APPLICATION FOR PERMIT TO DRILL, RE-ENTER, DEEPEN, PLUGBACK, OR ADD A ZONE

<sup>1</sup> Operator Name and Address CHEVRON USA INC 15 SMITH RD, MIDLAND, TX 79705		<sup>2</sup> OGRID Number 4323
		<sup>3</sup> API Number 30-025-29493
<sup>4</sup> Property Code 29957	<sup>5</sup> Property Name L.R. KERSHAW	<sup>6</sup> Well No. 12

CHEVRON U.S.A. INC. WOULD LIKE TO AMEND THE INTENDED PROCEDURE THAT WAS APPROVED ON 7-18-06. WE WILL NOT DOWNHOLE COMMINGLE, BUT WILL SQUEEZE THE BLINEBRY PERFS.

**LR Kershaw #12  
Monument Tubb Field  
Section 13, T20S, R37E, Unit C  
Lea County, NM  
30-025-29493**

**Current**  
**Wellbore Diagram**

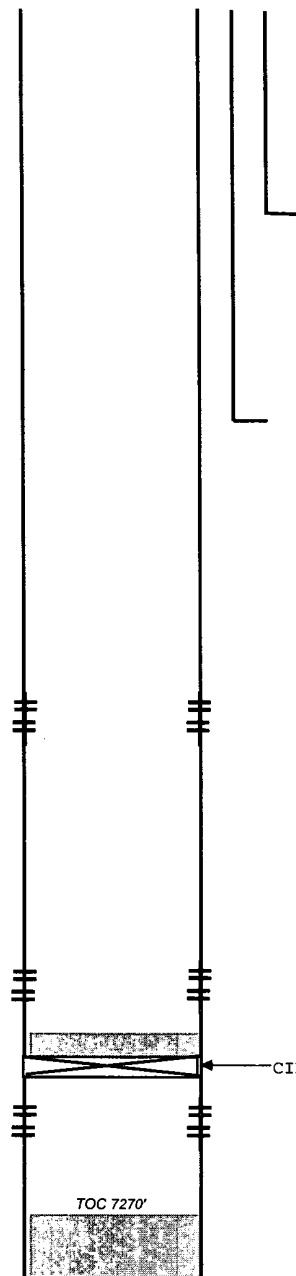
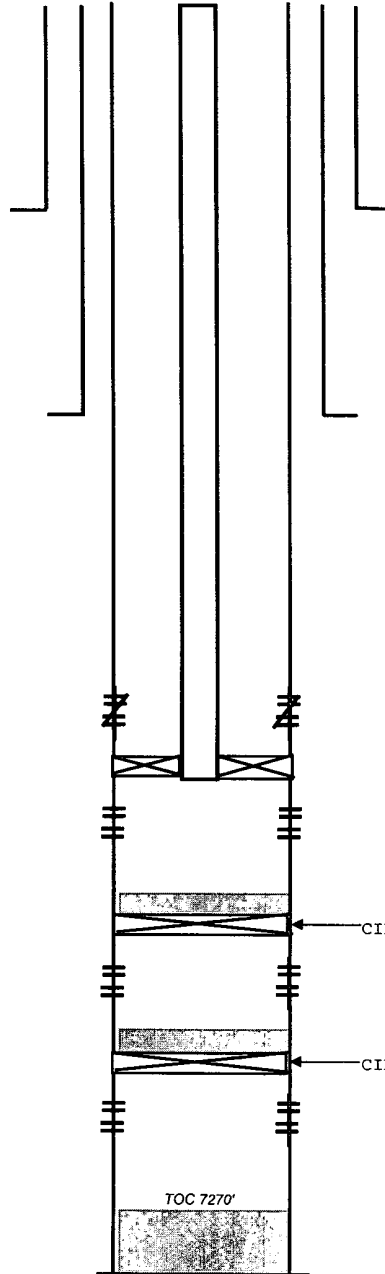
CHEVRON U.S.A. INC. INTENDS TO RECOMPLETE THE SUBJECT WELL FROM THE WEIR BLINEBRY EAST RESERVOIR TO THE MONUMENT TUBB POOL.

THE INTENDED AMENDED PROCEDURE AND THE CURRENT AND PROPOSED WELLBORE DIAGRAMS ARE ATTACHED FOR YOUR APPROVAL

**Proposed**  
**Wellbore Diagram**

Perfs: Status  
Tubb 6348' - 6567' opened
